# Modification Recommended Service Note

## N8945A - Autoranging System DC Power Supply, 80V, 340A, 10000W, 400 VAC

Serial Numbers: DE14290000 - DE15369999 without manufacturing ID Version "B"

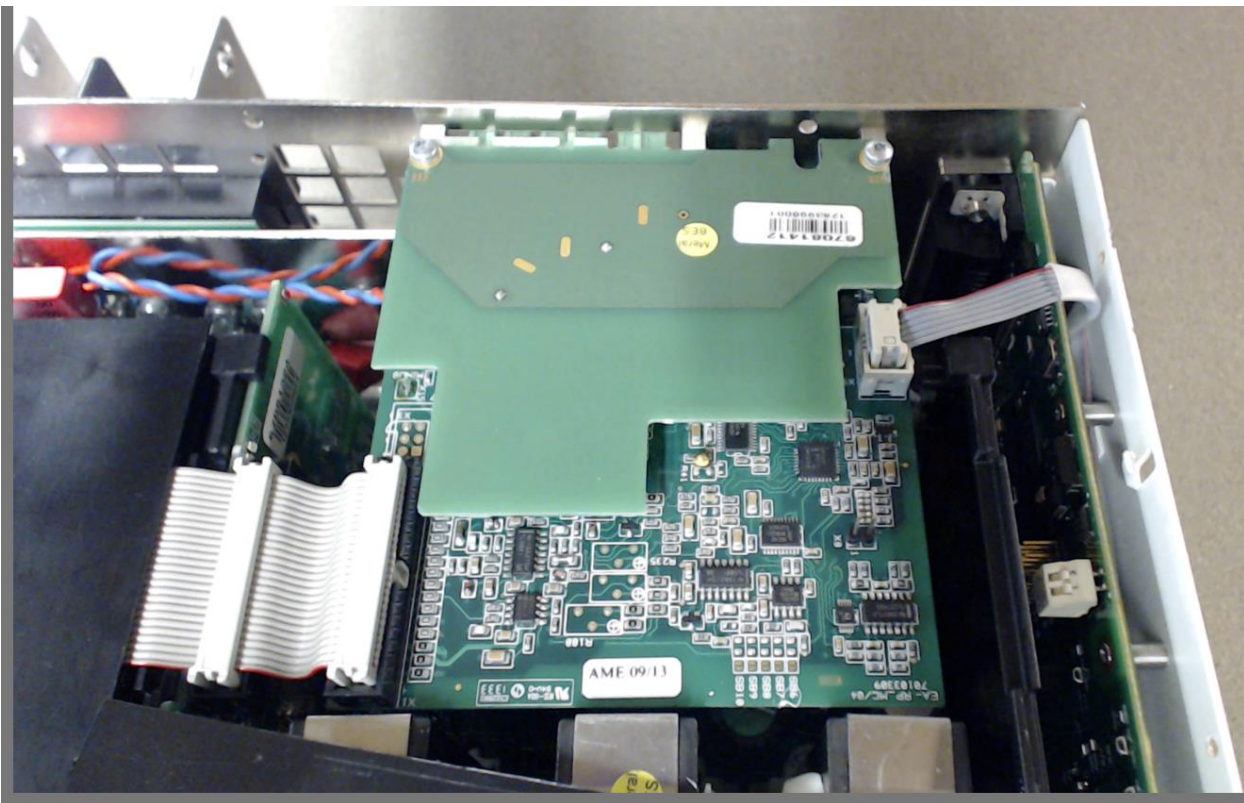
Resistors R93 and R94 must be removed, no replacement parts are required for modification.

Removal of two (2) surface mount resistors, R93 and R94, will correct this problem:

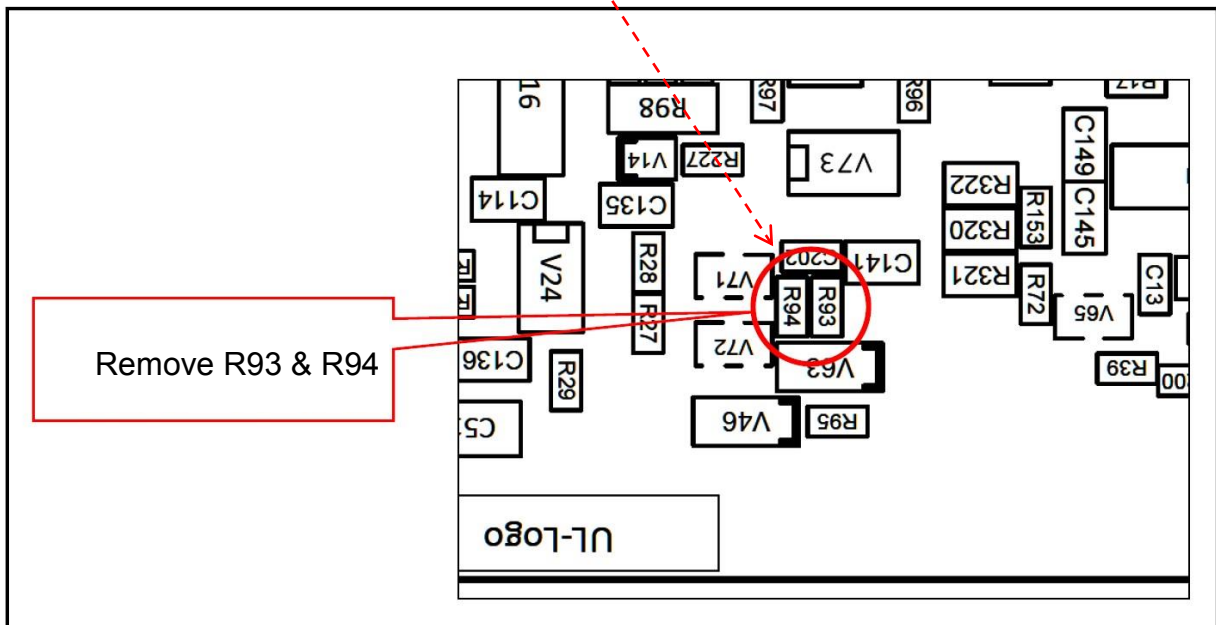
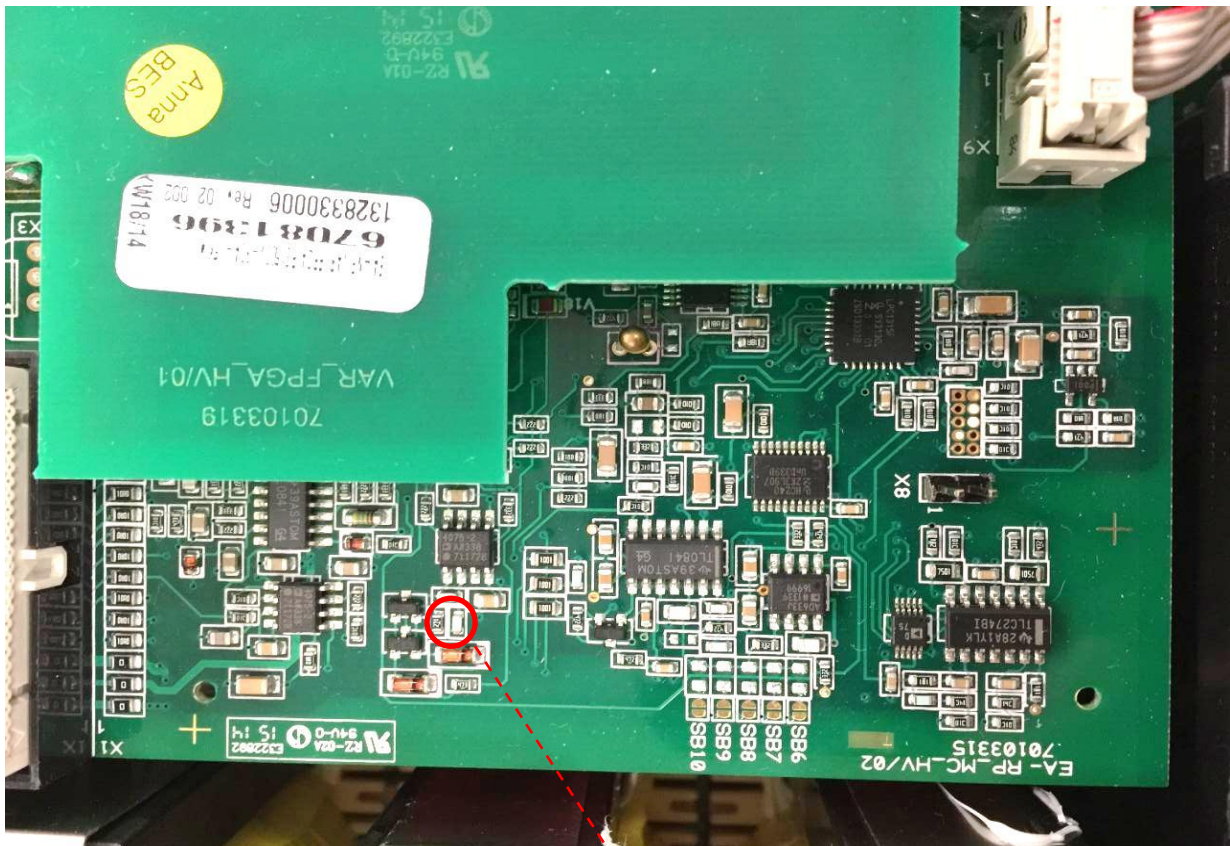
- 1) Remove acMains cable from power source.
- 2) Wait 5 minutes
- 3) Remove top cover from instrument.
- 4) In the 5kW units (viewed from the front of the unit), a small SMT assembly located at the right-rear of instrument will be readily visible (see below):

In the 10kW & 15kW units; although found in the same location, a black plastic cover will have to be removed to gain visibility and access to the SMT assembly. Plastic cover snaps-on and can be removed with a small screwdriver.

Suffix “B” added

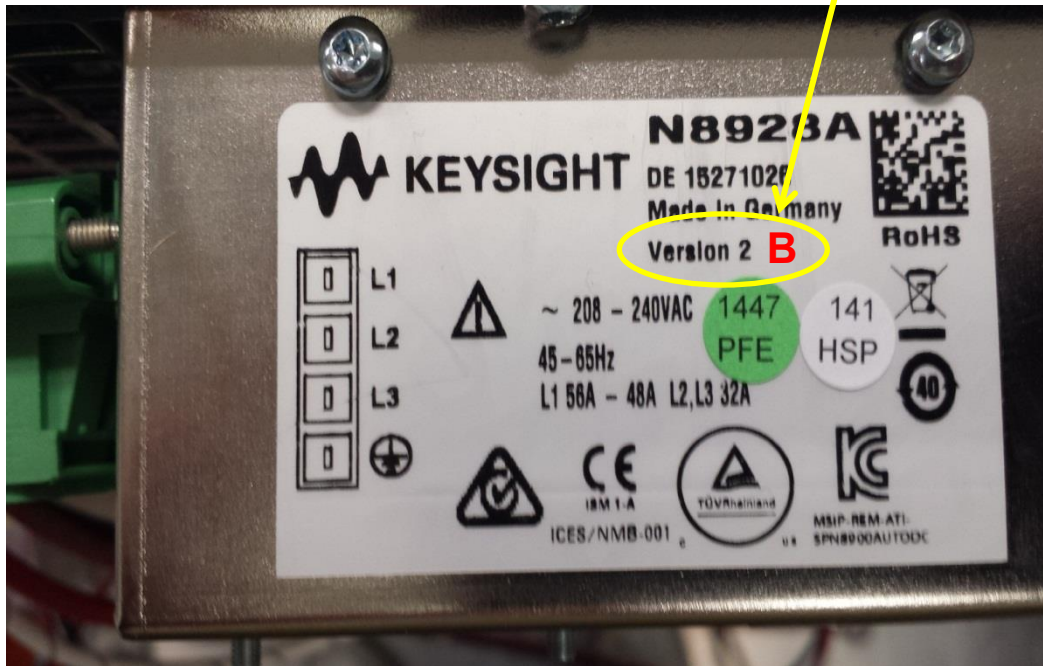
7) On the acMains label, on the rear of the instrument; use an indelible marker, to add the suffix letter “B” after the Version ID. This will assist in the tracking of modified instruments.
